Re: St. Lucie Unit 1
Docket No. 50-335
Inservice Inspection Plan
Fourth Ten-Year Interval Unit 1 Relief Request No. 8, Revision 0

RESPONSE TO REQUEST FOR ADDITIONAL INFORMATION (RAI)

RELIEF REQUEST NO. 8 INSPECTION OF REACTOR VESSEL

(TAC NO. MF4490)

Figure 1. Plot of Crack Growth Rate (da/dt) versus Stress Intensity Factor (K_I) for Alloy 690 Data from Plate Material Tested by CIEMAT

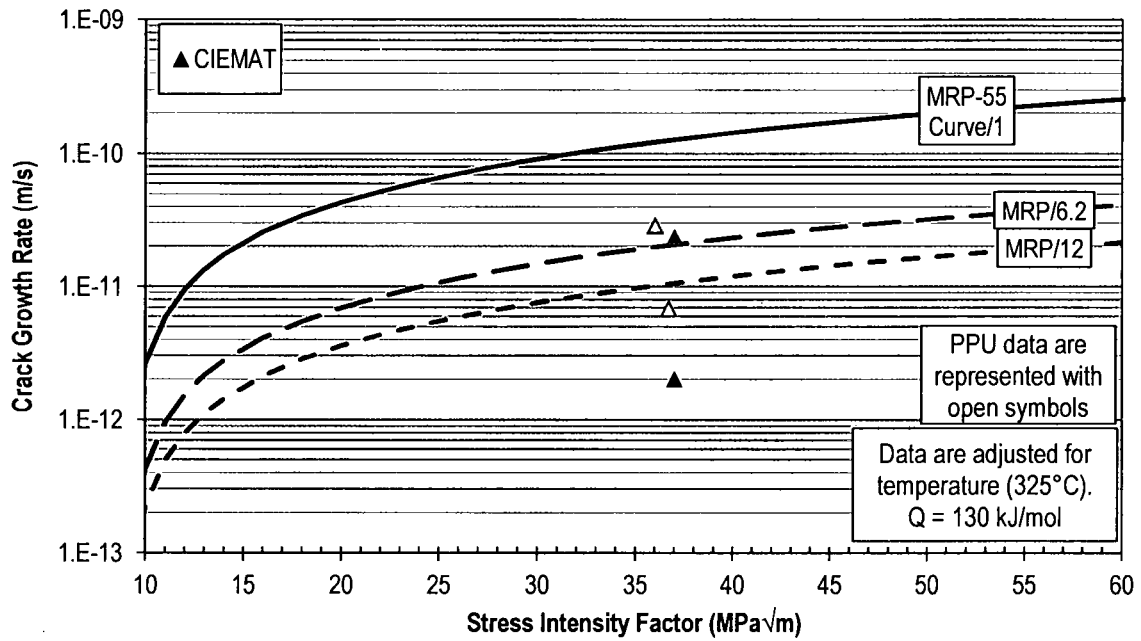
- Two of the points are from specimen 9ARB1, comprised of Alloy 690 plate material, tested at 340°C and 15 cc H₂/kg H₂O [8]. Both of these data are for the first half of segments that exhibited a crack growth rate that was an order of magnitude lower in the second half of the segment. A plot of crack growth rate versus crack-tip stress intensity factor (K) for the Alloy 690 data from MRP-375 for plate material tested by CIEMAT is provided here as Figure 1. These two points have minimal implications for the requested inspection interval extension for several reasons:

- As illustrated in Figure 1 and subsequent figures using open symbols, one of the two points was generated under partial periodic unloading (PPU) conditions. As discussed below in “Data Most Directly Applicable to Plant Conditions,” PPU conditions may result in accelerated crack growth rates that are not directly representative of plant conditions, especially for the case of alloys with relatively high resistance to environmental cracking like Alloy 690. The other data point obtained under constant load/K conditions is only slightly above the line representing a factor of 6.2 below the MRP-55 deterministic crack growth rate for Alloy 600.

Figure 2. Plot of da/dt versus K_I for Alloy 690 Data from Heat WP787

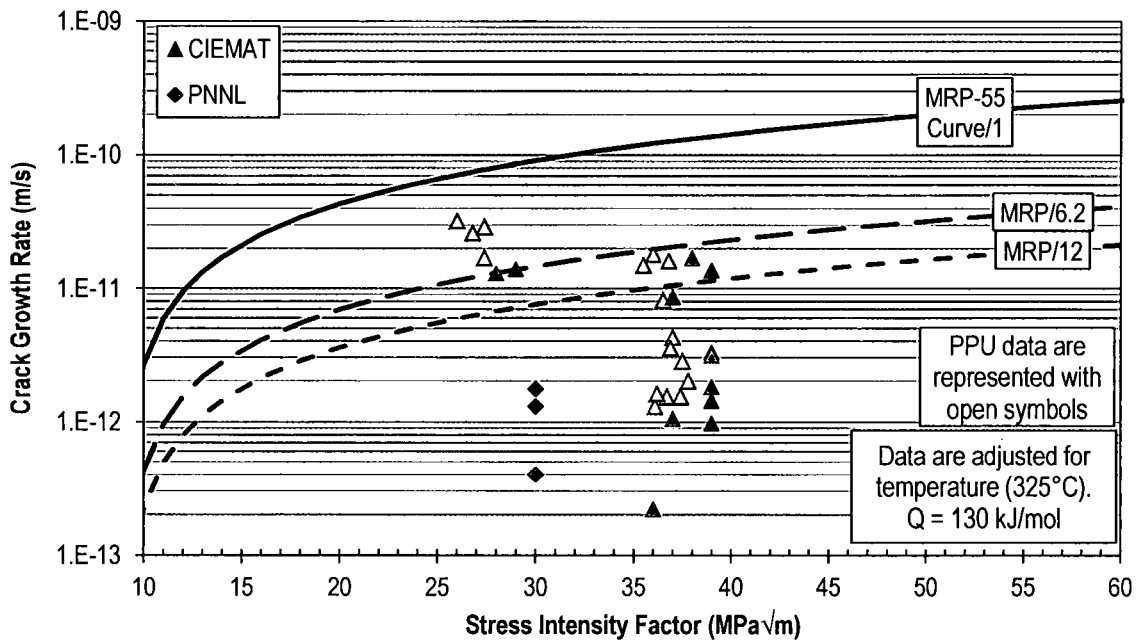
received material. The extent of transition along the crack front to intergranular cracking for these data was extremely low ($\leq 5\%$). A plot of crack growth rate versus K for the Alloy 690 data from MRP-375 for heat WP787 is provided here as Figure 2. As in Figure 1, there is significant growth rate variability within the data for the same heat of material. The median for the CIEMAT specimens is more than a factor of 12 below the MRP-55 curve. Four of the five points are for PPU testing; this method may accelerate growth beyond what would be expected for in-service components, as discussed later. Additionally, the Pacific Northwest National Laboratory (PNNL) data indicate that the specific laboratory that produces the data can significantly influence the reported growth rate, such that there is a substantial possibility that a small number of reported data points with relatively high crack growth rates from a single laboratory are not characteristic of the true susceptibility of a specific heat of Alloy 690 material.

Figure 4. Plot of da/dt versus K_I for Alloy 690 HAZ Data from Plate Material Tested by CIEMAT

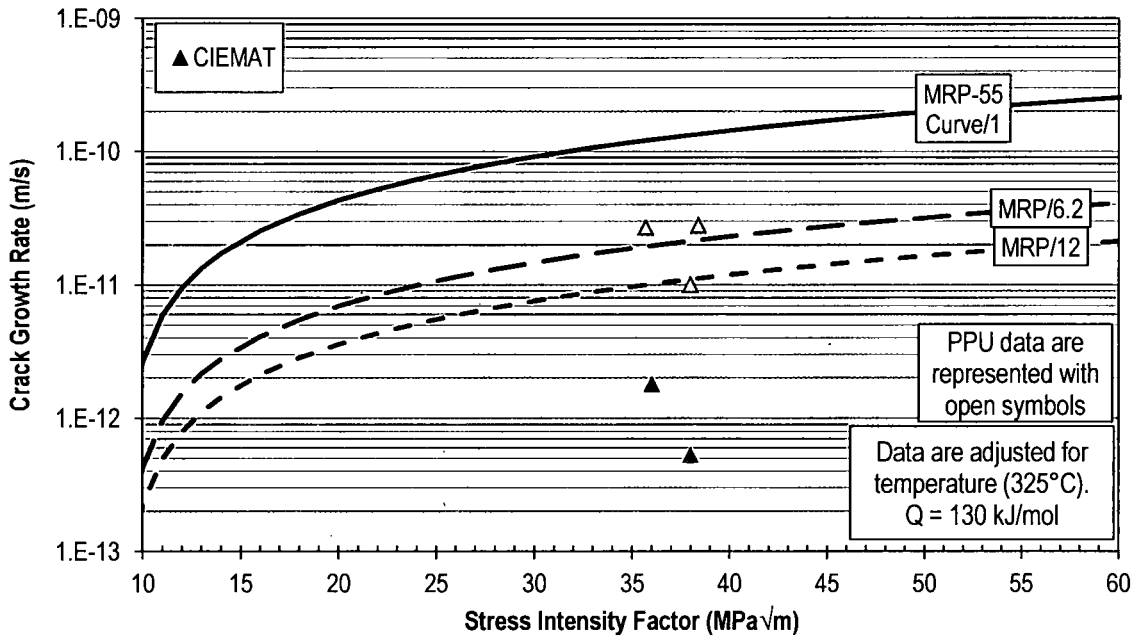
- The remaining two points are from CIEMAT testing of specimens 19ARH1 and 19ARH2, comprised of welded Alloy 690 plate material, tested at 340°C and 15 cc H₂/kg H₂O [8]. A plot of crack growth rate versus K for the Alloy 690 HAZ data from MRP-375 for plate material tested by CIEMAT is shown in Figure 4. As discussed later, the orders of magnitude difference between these two PPU points and the constant load testing for this HAZ is indicative of the substantial accelerating effect that PPU testing can have beyond what would be expected in service environments.

Figure 5. Plot of da/dt versus K_I for Alloy 152 Data from Heat WC83F8

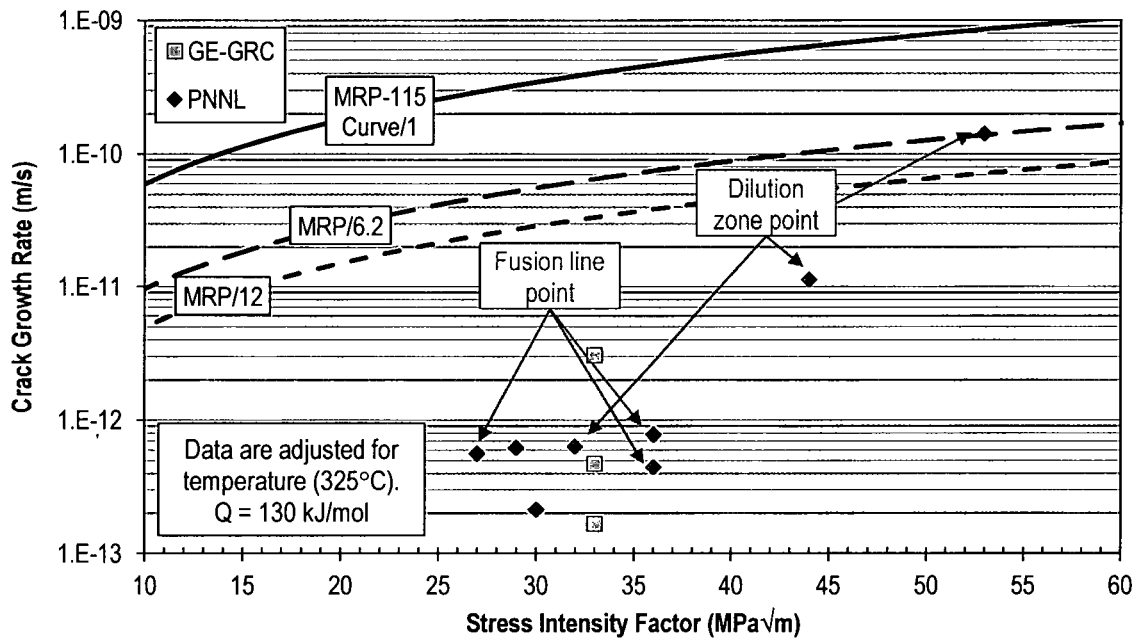
- One of these points is from PNNL testing of the dilution zone of a dissimilar metal weld between 152M (Special Metals heat WC83F8) and carbon steel, tested at 360°C and 25 cc H₂/kg H₂O [11]. This material condition is not applicable to the wetted surfaces of CRDM nozzle J-groove welds because the dilution zone where Alloy 52/152 contacts the low-alloy steel RV head is below the stainless steel cladding. A plot of crack growth rate versus K for the Alloy 152 data from MRP-375 for heat WC83F8 is provided here as Figure 5.

Figure 6. Plot of da/dt versus K_I for Alloy 152 Data from Heat WC04F6

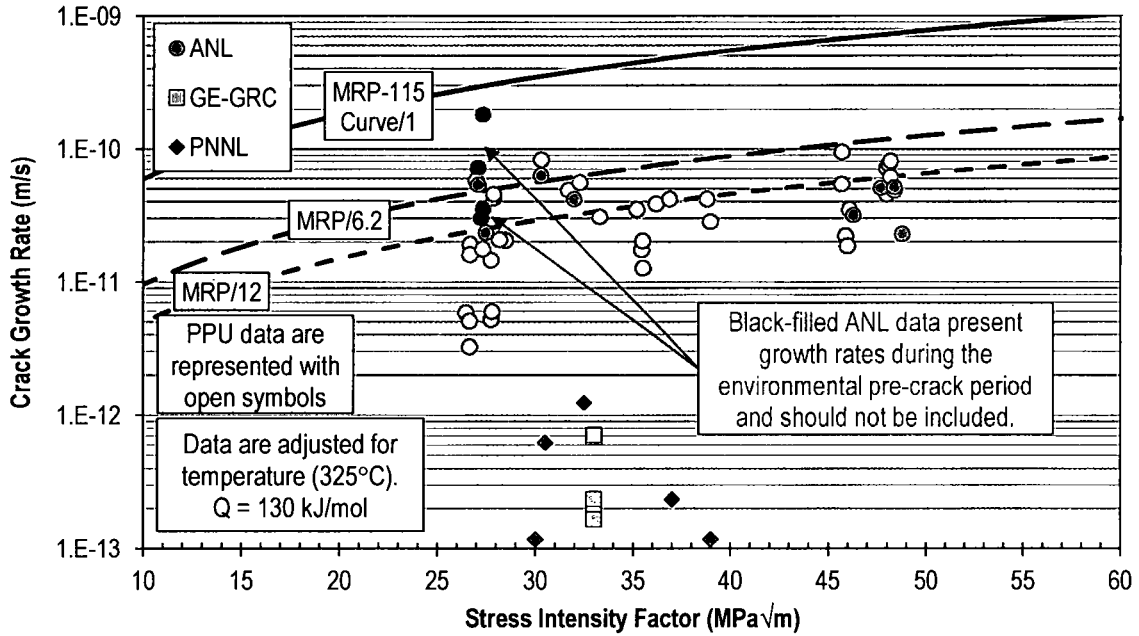
- The remaining four data points represent three specimens from Alloy 152 weld material (Special Metals heat WC04F6) that were tested by ANL at 320°C and 23 cc H₂/kg H₂O ([12] and [13]). These Alloy 152 specimens came from welded plate material. A plot of crack growth rate versus K for the Alloy 152 data from MRP-375 for heat WC04F6 is provided here as Figure 6. Two of these points were for PPU conditions. The other two points were for constant load/K conditions, which are most directly relevant to plant conditions, but are located only slightly above the line representing a factor of 6.2 below the MRP-115 deterministic crack growth rate for Alloy 182. Figure 6 shows a very large variability in the crack growth rate reported by different laboratories for this heat of Alloy 152 weld material. Roughly one third the ANL data, all of the GE data, and all the PNNL data for this heat are for specimens from a single weld made by ANL, illustrating the role of experimental variability. A small number of elevated data points for a weld produced by a single laboratory may not be representative of the true material susceptibility.

- In some cases, different laboratories have reported large differences in crack growth rate for the same material heat or test weld. This behavior is illustrated in Figure 6 for the Alloy 152 heat WC04F6 and Figure 24 for the Alloy 690 heat WP142. Thus, individual data points showing relatively high crack growth rates might not reflect the true susceptibility of particular categories of nozzle or weld material. Consistent data from multiple laboratories may be needed before one can conclude that a particular category of nozzle or weld material has an elevated susceptibility to PWSCC growth.

Figure 7. Plot of da/dt versus K_I for Alloy 690 Data from All Laboratories, $\leq 10\%$ Cold Work, Constant Load or K_I

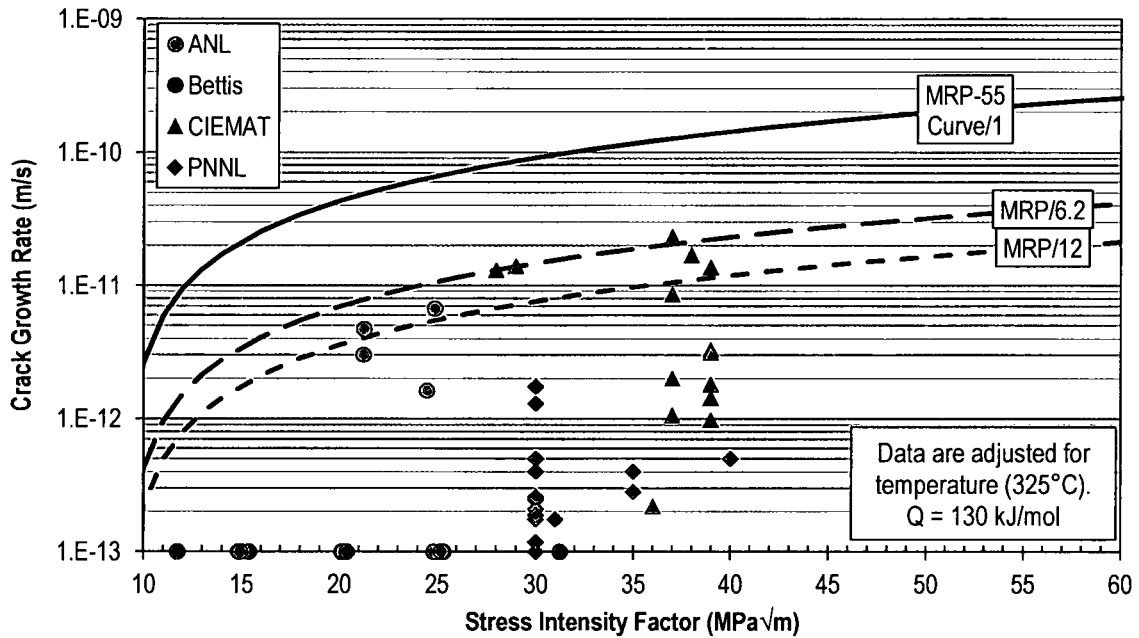
- *Figure 7 for Alloy 690 with Added Cold Work Less than 10%.*
 - Only two points are within a factor of 6.2 below the MRP-55 deterministic crack growth rate for Alloy 600.
 - Figure 8 shows that the data are bounded by a FOI of more than 12 relative to Alloy 600 data on a statistical basis.

Figure 9. Plot of da/dt versus K_I for Alloy 690 HAZ Data from All Laboratories, $\leq 10\%$ Cold Work, Constant Load or K_I

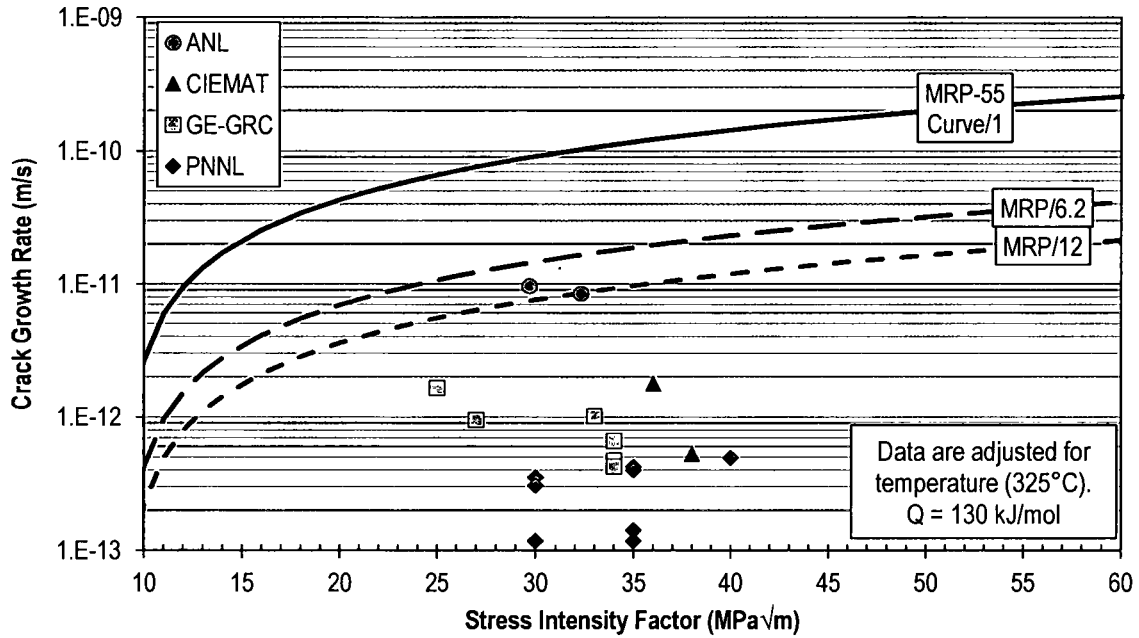
- *Figure 9 for Alloy 690 HAZ.*
 - None of the 24 points are within a factor of 6.2 below the MRP-55 deterministic crack growth rate for Alloy 600.
 - Figure 10 shows that the data are bounded by a FOI of more than 12 relative to Alloy 600 data on a statistical basis.
- *Figure 11 for Alloys 52/152.*
 - Only two of 83 points are within a factor of 6.2 below the MRP-115 deterministic crack growth rate for Alloy 182.
 - Figure 12 shows that the data are bounded by a FOI of more than 12 relative to Alloy 182 data on a statistical basis.

Figure 11. Plot of da/dt versus K_I for Alloy 52/152 Data from All Laboratories, $\leq 10\%$ Cold Work, Constant Load or K_I

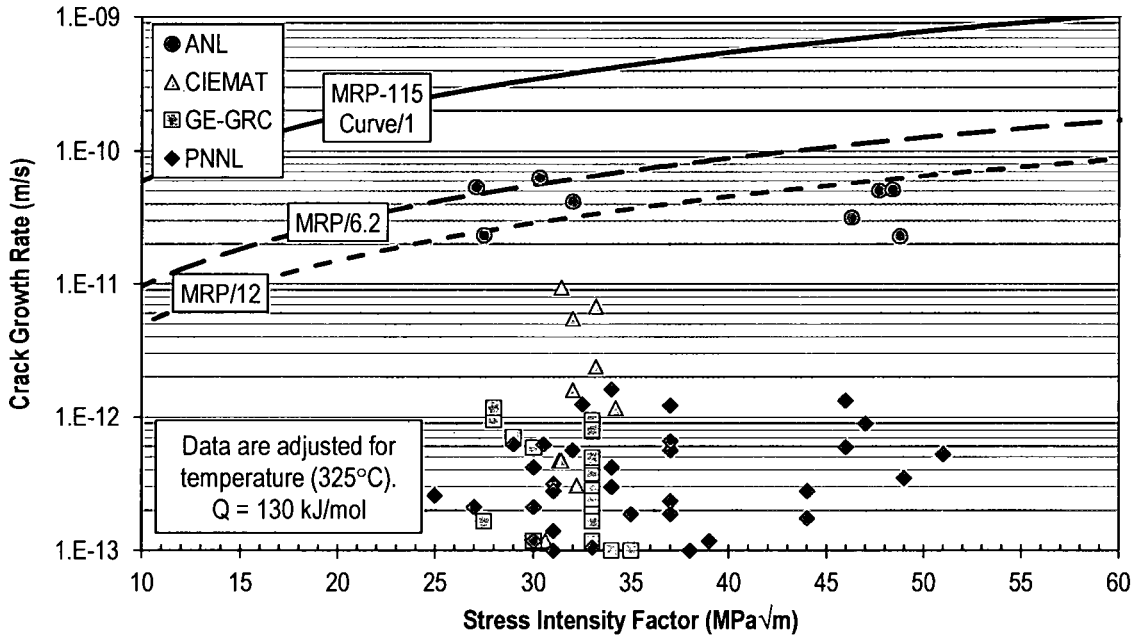
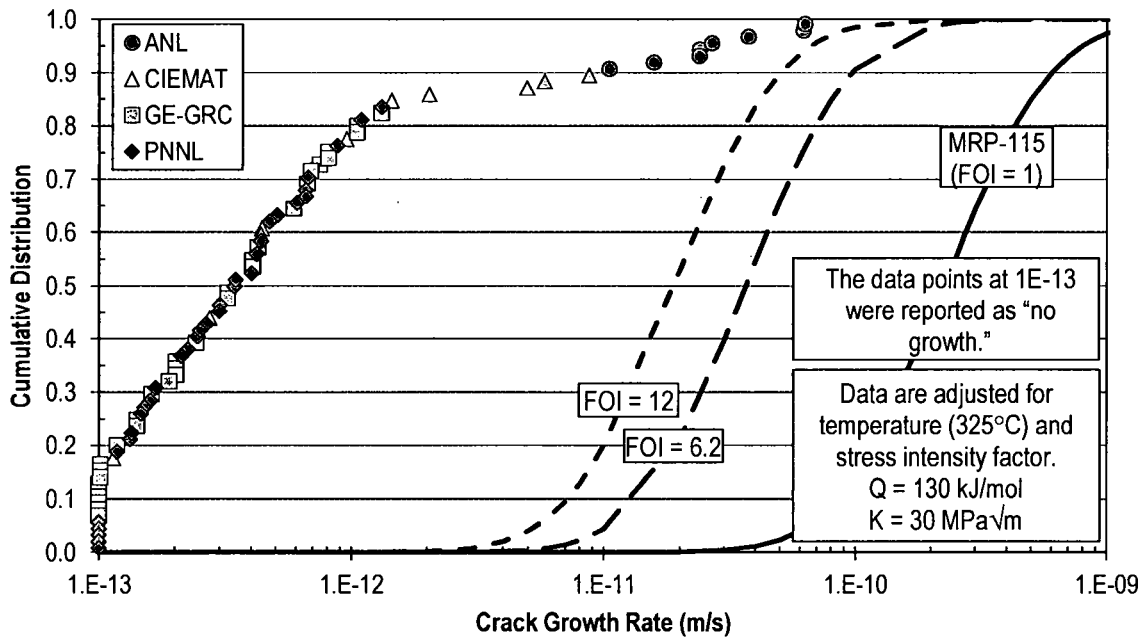
- The Alloy 52/152 weld metal data shown in Figure 3-5 and Figure 3-6 of MRP-375 include data reflecting a range of weld dilution levels. The data presented in Figure 11 and Figure 12 exclude the weld dilution data points. The weld dilution data are not reflective of the full chromium content of Alloy 52/152 weld metal.

- The data presented in Figure 11 and Figure 12 exclude a small number of data points that reflect cracking at the fusion line with carbon or low-alloy steel material. Some of

- The data presented in Figure 11 and Figure 12 eliminate the few data points that in fact reflect fatigue pre-cracking rather than stress corrosion cracking. The status of these data points was clarified subsequent to publication of MRP-375.
